Office Action Summary	Application No. 10/711,822	Applicant(s) MOODY ET AL.	
	Examiner BRANON C. PAINTER	Art Unit 3633

DETAILED ACTION

Reproduced from Ryan

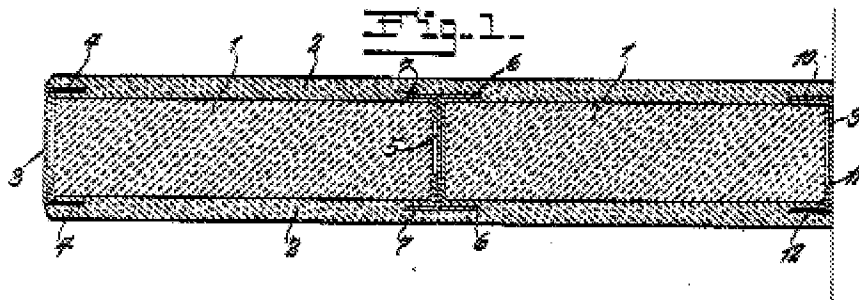
10. Regarding claim 13, Ryan discloses an end cap having all of the applicant's claimed structure, including:

- a. An approximately vertical web (3, Fig. 1, 6).
- b. Flanges projecting from each edge at approximately right angles to one side of the web (4).
- c. An approximately vertical edge of rigid insulation disposed between the flanges (1).
- d. The examiner notes the phrase "for use in....edge" is considered a recitation of intended use. As such, it is given little patentable weight. That said, the tile 1 disclosed by Ryan could be considered rigid insulation disposed between the flanges.

Reproduced from Carver

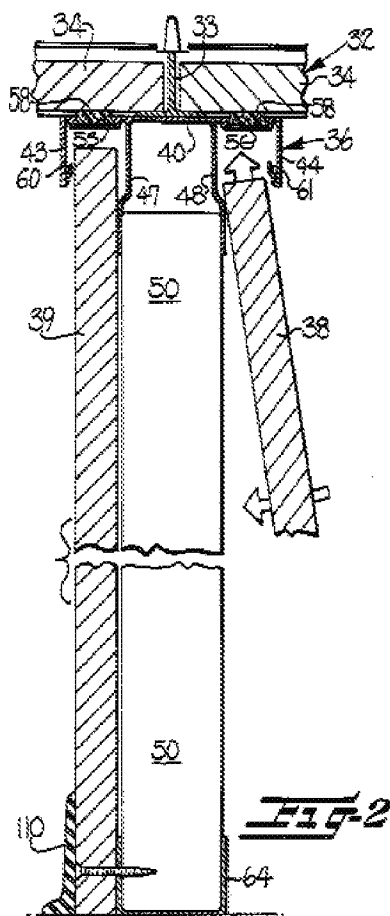
13. Claims 1-2 are rejected under 35 U.S.C. 103(a) as being unpatentable over Carver (4,361,994).

a. Carver discloses a wall system including:

- i. A top track (36e) with horizontal web, first flange, and second flange extending down at right angles (amended Fig. 25).
- ii. A top plate (70) with horizontal web, first flange, and second flange extending down at approximately right angles (amended Fig. 25). The examiner notes that the flanges are considered to be the entire left and right hand members of plate 70, and that these members do extend downward as claimed.
- iii. Wherein the top plate is disposed in the top track such that the webs and first flanges are in close and complimentary relation and an opening is formed between the second flanges (amended Fig. 25).

- iv. Vertical studs mounted to and extending between the top and bottom plates, wherein the top and bottom plates oppose each other (50, Fig. 2, 25).
- b. Carver does not expressly disclose a bottom track or plate extending upwardly in the same structural manner as the top track and plate.
- c. At the time of the invention, it would have been obvious to a person of ordinary skill in the art to modify the bottom tracking of Carver by replacing it with the same tracking used on the top of the wall system (orienting it, as would be obvious from the orientation of bottom tracking 64, in an upward-facing manner), in order to provide a wall system whose wallboards can be attached without the use of fasteners.

Reproduced from Carver (amended)

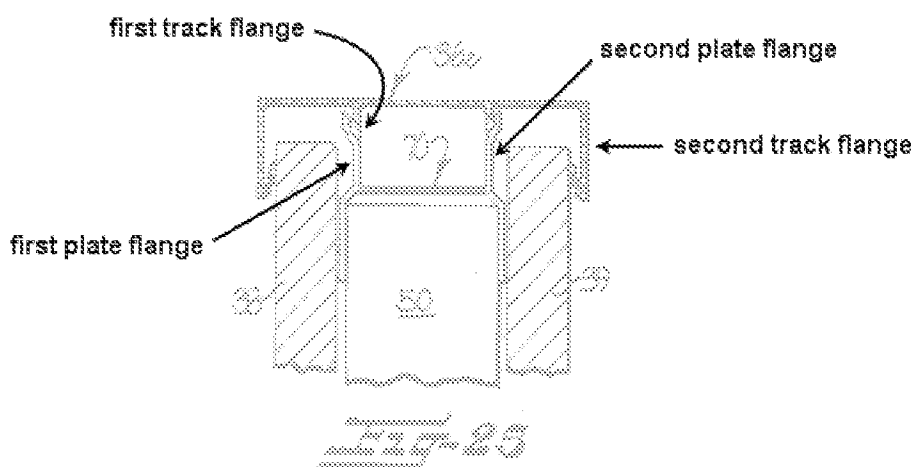
14. Regarding claim 2, Carver as modified above further discloses rigid insulation between the top and bottom tracks, including two horizontal edges disposed in the longitudinal openings and two vertical edges (39, Fig. 25). The examiner notes that 39 is disclosed as a wallboard panel. However, wallboard panels have a rigidity and insulative properties, and as such meet the claim limitations.

Reproduced from Caldwell

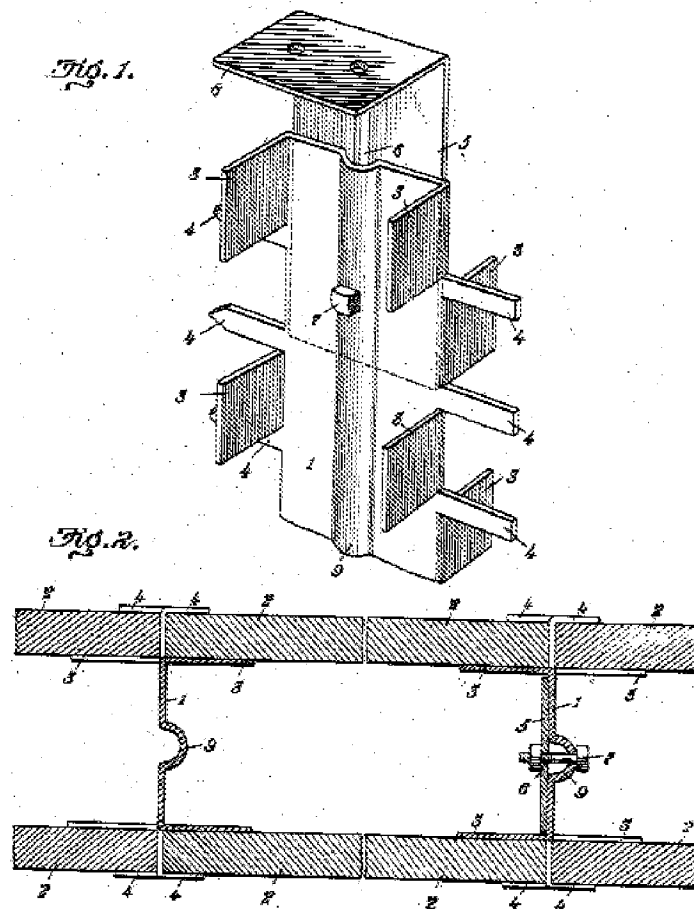
- c. Caldwell discloses a vertical framing component extending between the top and bottom plates (1, Fig. 1) including an elongated planar web (Fig. 1) with projections from each edge at right angles in both directions (3, 4) such that a slot is formed on each side of the web (slot formed between 3 and 4 for receiving insulating boards on both sides, Fig. 2; the examiner notes a slot is also formed between two tabs on separate framing elements which face one another).

- d. At the time of the invention, it would have been obvious to a person of ordinary skill in the art to modify the wall system of Carver by adding panel-holding framing components as taught by Caldwell, in order to provide the panels of Carver with support and alignment at their vertical edges.

19. Regarding claim 7, Carver/Caldwell as modified above further discloses vertical edges of panels disposed in a slot of the framing component (Caldwell: 2 in slot between 3 and 4, Fig. 2; when used in combination with Carver as discussed above, Carver's panels 39 would be disposed in this slot).

20. Regarding claim 9, Carver/Caldwell as modified above further discloses an elongated planar web with longitudinal axis, a second edge parallel the axis a first and second side (Caldwell: 1, Fig. 1), with first and second tabs extending from the first edge approximately 90 degrees from the first and second sides, respectively (3, 3, Fig. 1), and a third tab extending from the second edge approximately 90 degrees from the second side (3, 3, Fig. 1).

Reproduced from Poliquin

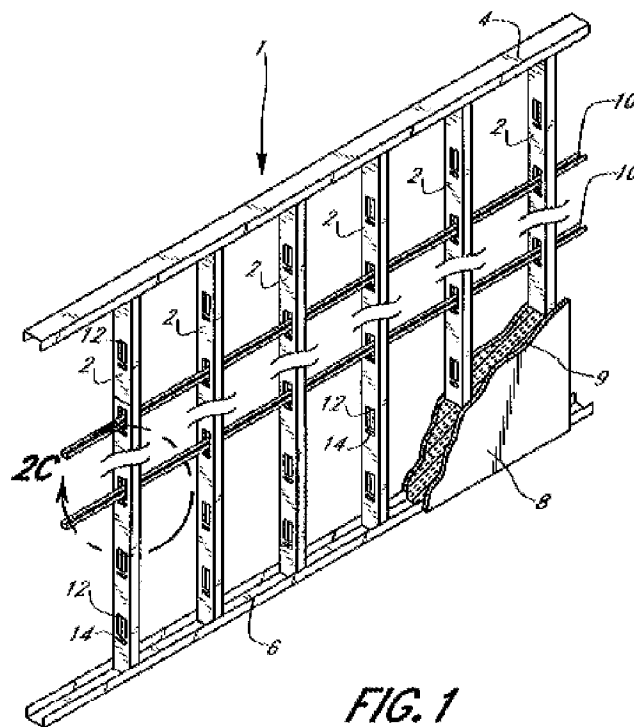
- a. Carver/Campbell discloses a wall system as set forth above.
- b. Carver/Campbell does not expressly disclose that the studs and framing components are mounted to horizontal blocking.
- c. Poliquin discloses a plurality of vertical components mounted to horizontal blocking approximately halfway between top and bottom plates (2 mounted to 10 halfway between 4 and 6, Fig. 1). The mounting is facilitated by cut-outs 12 in the vertical members.
- d. The examiner further notes motivation for combining the references as set forth in Poliquin ([0005]).
- e. At the time of the invention, it would have been obvious to a person of ordinary skill in the art to modify the studs and framing components of

Carver/Campbell by providing them with cut-outs midway along their height and mounting horizontal blocking through the cut-outs as taught by Poliquin, in order to connect and bridge the studs and framing components, improving the wall system's strength and resistance to buckling.

- f. The examiner further notes that it would have been an obvious matter of design choice to modify Carver/Campbell by including horizontal blocking halfway between the top and bottom plates, since it is notoriously well-known in the art to use this structure to reinforce and strengthen the framework of a wall system.

Fig. 2

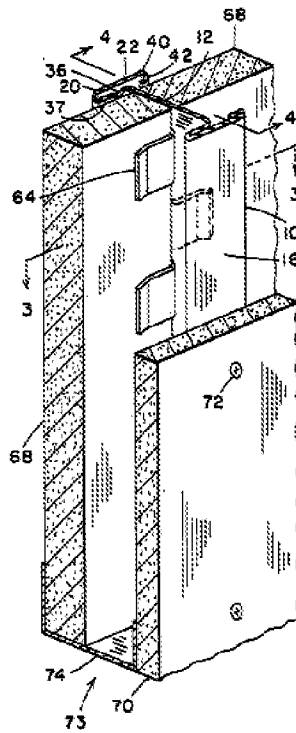
- c. Rutkowski discloses a wall system with a stud connected to a vertical framing component extending between the top and bottom plates (10, Fig. 2; amended Fig. 5) including an elongated planar web (amended Fig. 5) with projections from each edge at right angles in both directions (64, 22) such that a slot is formed on each side of the web (slot receiving 68).

Fig. 5

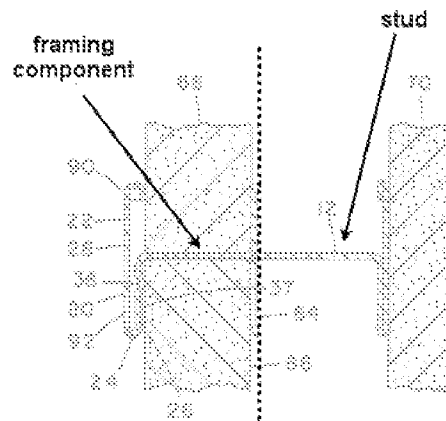
31. Regarding claim 6, Carver/Rutkowski as amended above further discloses a plurality of thermal framing components mounted to steel studs (connected framing component and stud, amended Fig. 5).
